**PRODUCT MODEL NAME: Plasmon 1800 SCSI Option Box**

**DATE: 1/20/2000**

**PTI#: 1800-01**

**386 SCSI Option Box with Plasmon LMS 6100 Drives**

Figure 3: 386 Processor & Logic SCSI Chip Location

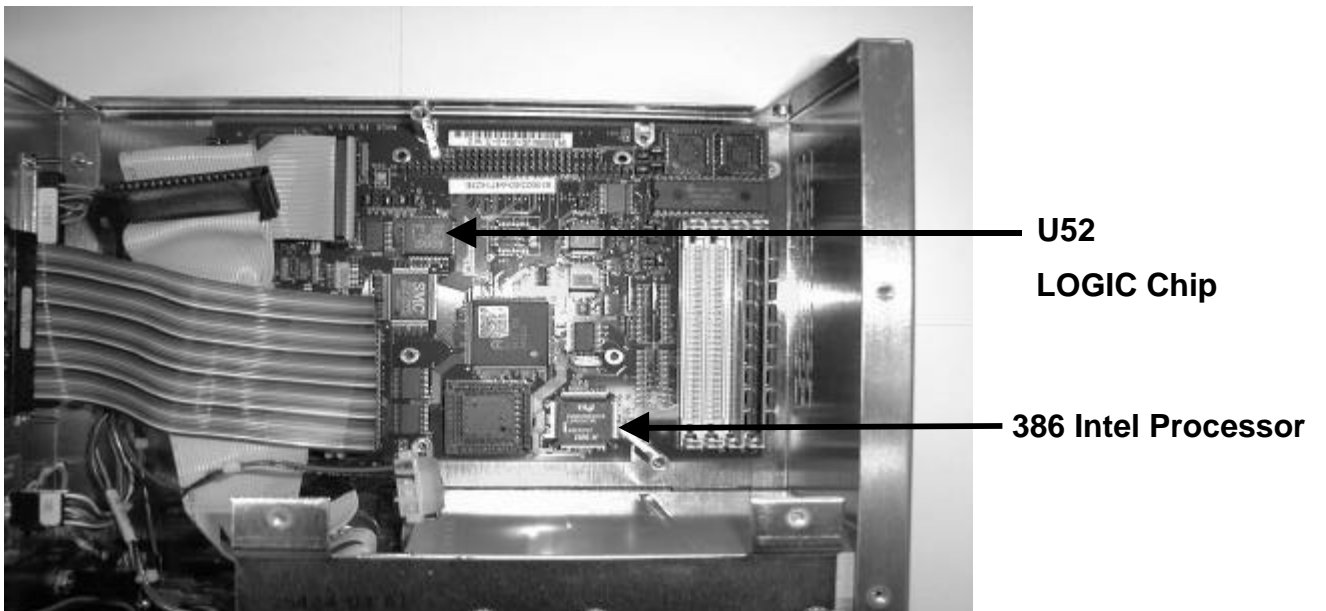
**Problem Description:** Under certain instances and heavy usage the jukebox will loose communications and/or appear as a SCSI Bus lock-up. This **ONLY** affects the 386 Option box and **NOT** the 186 Option box.

**Solution:** Replace the AMPRO board in the SCSI Option box part number 27990-00 Rev. D to 27990-00 Rev. E.

4. Verify that U25 on the AMPRO PCB is a Logic L53C80JC chip. If it is replace the AMPRO PCB (Replaced chip will be NCR or Symbios brand).
5. If the SCSI interface is differential you will need to remove the Paralan board which is held above the AMPRO PCB by 2 standoffs. For Single Ended SCSI proceed to step 6.

7. Remove the 4 screws/standoffs from the AMPRO PCB, remove and replace the board.
8. Reinstall all covers.
9. Apply the SCSI PTI label to the top of the option box (Fig 4).
